ZONING BOARD OF APPEALS  
STAFF REPORT  
May 19, 2016

Area Variance

**File Number:** V-063-15-16

**Project Address:** 980 West Ridge Road

DRAWING TITLE:  
**SITE PLAN NEW**

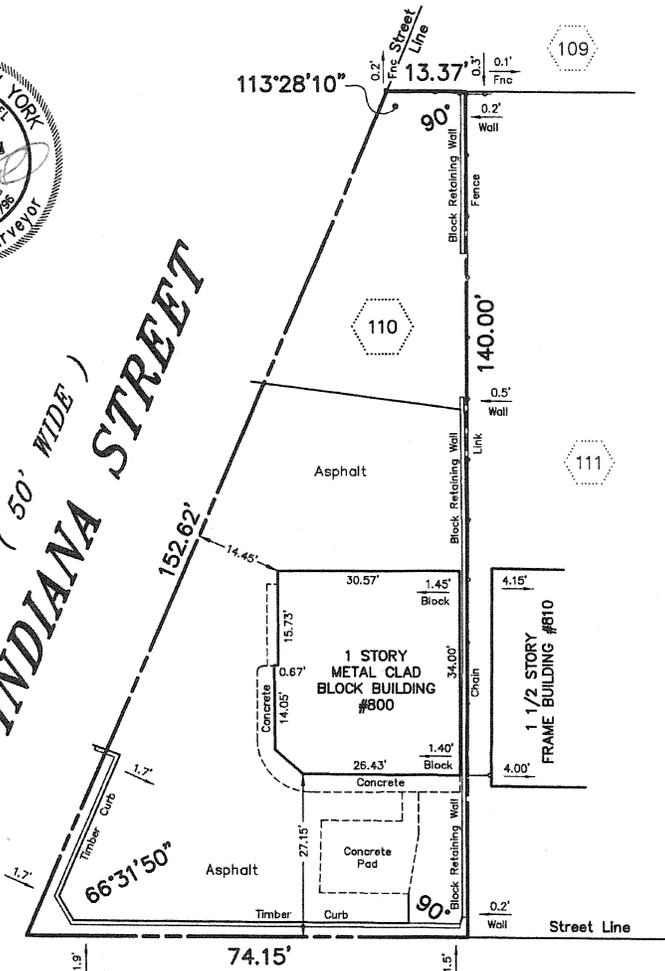
9. Parking for vehicle-related uses is required at two spaces per repair bay, for a total of two in this case, and those two are provided. One of those two must provide handicap access, and the site plan correctly shows this. The maximum number of spaces permitted is 110% of the minimum, or three in this case.

10. A perimeter landscape strip at least 10 feet wide is required along both street fronts. Along the south and southeastern fronts, the hedgerow, though narrow, was planted pursuant to a Site Plan Approval in 1980, issued in conjunction with the variance establishing vehicle repair. Along Indiana Street, however, views to the repair bay from nearby residences must be blocked by some form of screening. To this end, a row of 6 new arbor vitae are shown to be planted in the north yard.

**SITE PLAN**

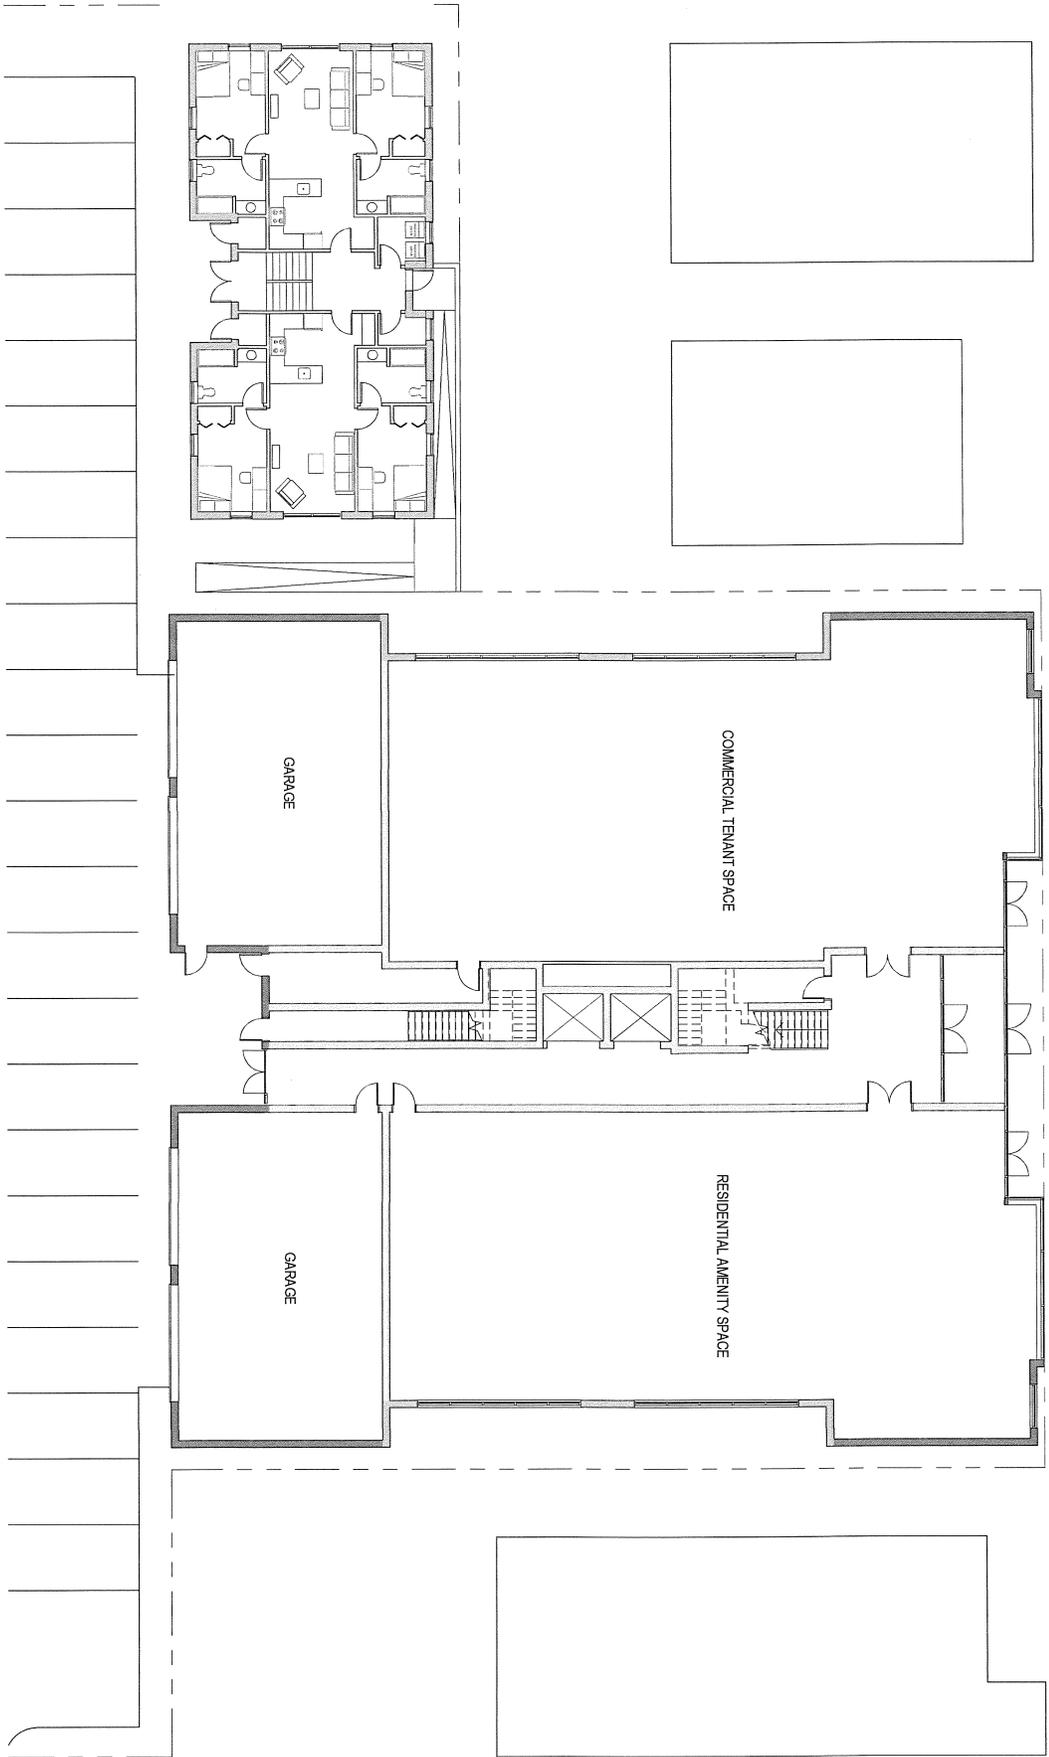
- a. The minimum front yard setback of a principal use fronting Langslow and Gold Streets must be either the average setback of buildings on the block or 20 feet, whichever is more. In addition, parking may not be within 10 feet of a front property line unless screened with a fence or wall combined with plantings. Neither setback is dimensioned on the site plan, but both are less than the 20 foot minimum, thus requiring a waiver from the Planning Commission. If this is denied, the number of parking spaces falls below the number required.

- b. Side yard setbacks must be at least 10 feet each and a combined total of 25 feet. Both side yards of the existing parking lot at 17 Langslow Street are less than the minimum, requiring a second waiver, reduction of the pavement, and/or purchase of a portion of 33 Langslow Street. On the proposed extension of the parking lot onto the Gold Street lots, both side yard setbacks appear compliant, but the plan must show dimensions.

- d. Landscaped islands are required in a parking lot at a rate of one per 15 parking spaces, or four in this case, with each island equivalent in size to a parking space at 162SF. The applicant may submit an alternative means to meet the screening intent of the landscaping requirements that may include masonry or stone walls, more mature plant materials, hedges, public art or other similar amenities to improve the aesthetics of the site. The plan would require a fourth waiver.

- e. The surface of the parking lot must be all-weather, durable and dustless, and be graded and drained to manage stormwater on site. Water may not shed across property lines nor into the public right of way. A grading plan must be provided.

- f. According to the provided survey map, the eastern curb of the existing parking lot at 17 Langslow and an adjacent fence are on the parcel at 33 Langslow, which is under separate ownership. The site plan shows that two 20 foot tall parking lot lights would be installed on this adjacent property. The applicant must remove the intrusions, purchase a portion of land, or provide evidence of an easement over the neighboring property.

- h. The trash enclosure is placed close to a private home and must be relocated to the interior of the site or within the building.
  - i. All other aspects of the parking lot comply with the zoning code, including access, aisle width, dimensions and striping of parking spaces and lighting.
3. **Area Variance** approval from the Zoning Board of Appeals is required for the following two requirements, which are described in more detail in the Findings below.
- a. Not meeting a required rear yard setback of 20 feet, where only 3 feet is provided;
  - b. Not meeting the Citywide Design Guidelines for having a building's main entrance face the public street. The entrance of the Gold Street building faces the parking lot, not the street.
